**Re: 173 Huntmar Drive
Community Transportation Study (dated June 5, 2014)
Addendum #1**

This Addendum has been prepared to reflect the latest revised Concept Plan (see attached) and to respond to comments received from the City of Ottawa, dated September 9, 2014, with regard to the above-noted Community Transportation Study.

Figure 1: Revised Existing Traffic Volumes

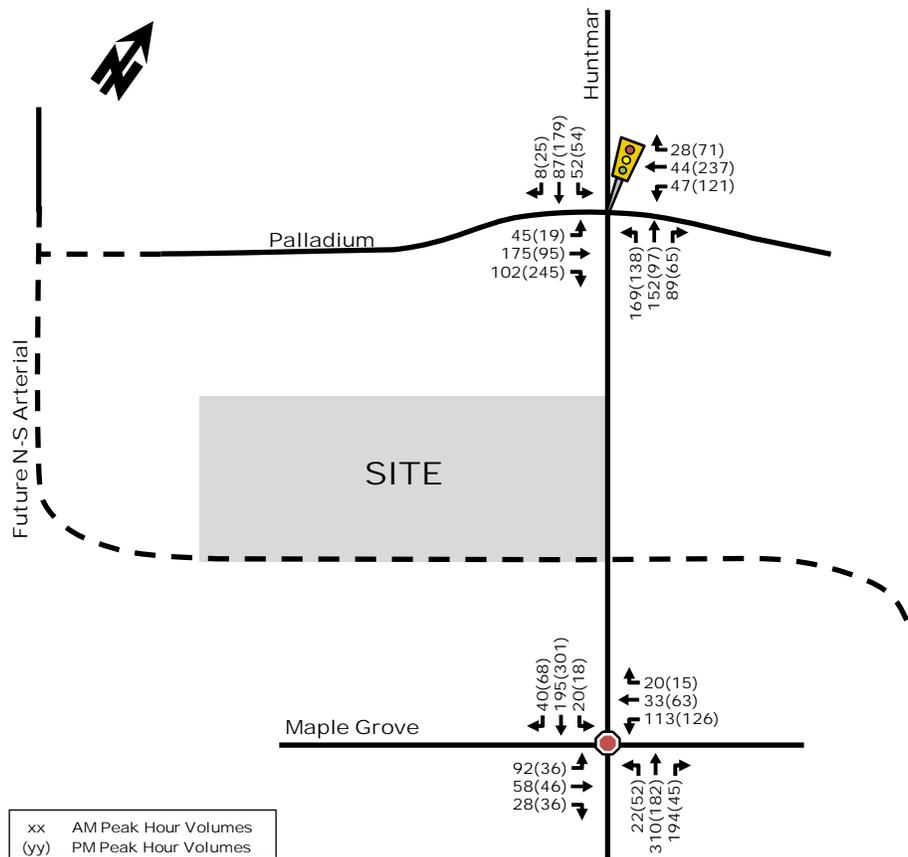
Based on City comments, the following is a review of existing traffic conditions using more recent traffic data at study area intersections.

The existing traffic volumes illustrated in Figure 5 of the original CTS were collected in 2012. The following Figure 1 depicts more recent peak hour traffic volumes, which were collected in 2013/2014 and are included as Appendix A. When comparing the most recent traffic data to the 2012 traffic volumes, with the exception of the northbound and southbound movements along Huntmar Drive (south of Maple Grove Road), the 2013/2014 peak hour traffic volumes along Huntmar Drive are less than (or very similar to) the 2012 peak hours traffic volumes used for analysis purposes, included in the original report. Therefore, the results, findings and conclusions included in the original report remain valid. Nevertheless, the following Table 1 summarizes the existing conditions at study area intersections, based on more recent traffic data.

With respect to Annual Average Daily Traffic (AADT) volumes, 2013/2014 AADT volumes along Huntmar Drive are noted as 18% higher than the 2012 AADT volumes. However, it should be noted the projected intersection operations included in the original report are based on weekday morning and afternoon peak hour volumes (as per the City's Transportation Impact Assessment Guidelines), which are considered to be the

most critical time periods during an average weekday (i.e. the highest volumes were used for analysis purposes). Therefore, the results, findings and conclusions included in the original report remain valid.

SITE PLAN

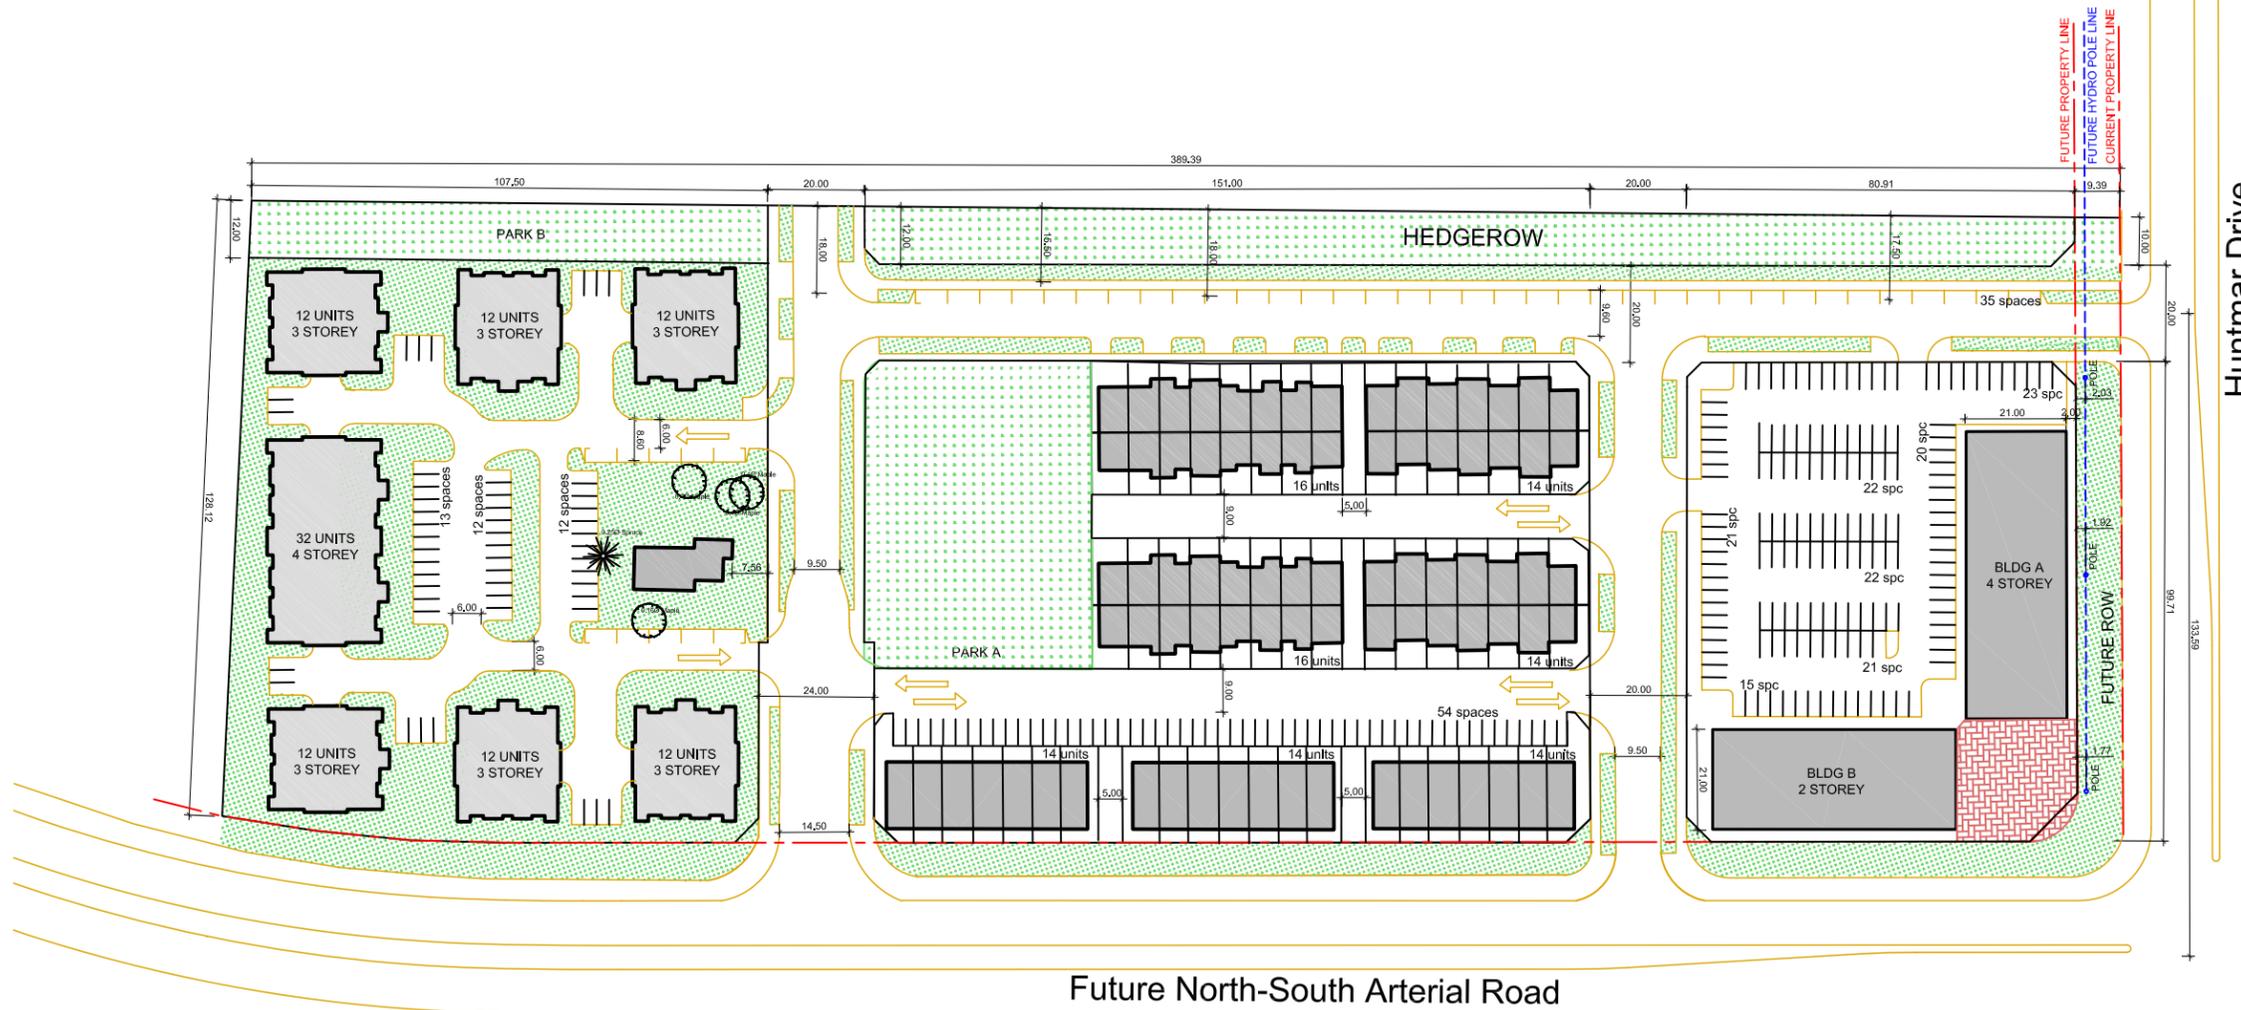
With regard to on-site circulation, the proposed Concept Plan is laid out effectively, provided that STOP control is implemented on the minor approaches at on-site intersections and appropriate signage (e.g. Do Not Enter and One-Way, etc.) is installed where One-Way circulation is desired.

As depicted in the proposed Concept Plan, sidewalks are proposed throughout the site, providing good connectivity between on-site land uses and the future pedestrian network adjacent to the site.

Bicycle parking is not identified on the proposed Concept Plan. Bicycle parking should be provided in well-lit areas/close to building entrances and a rate to meet By-Law requirements.
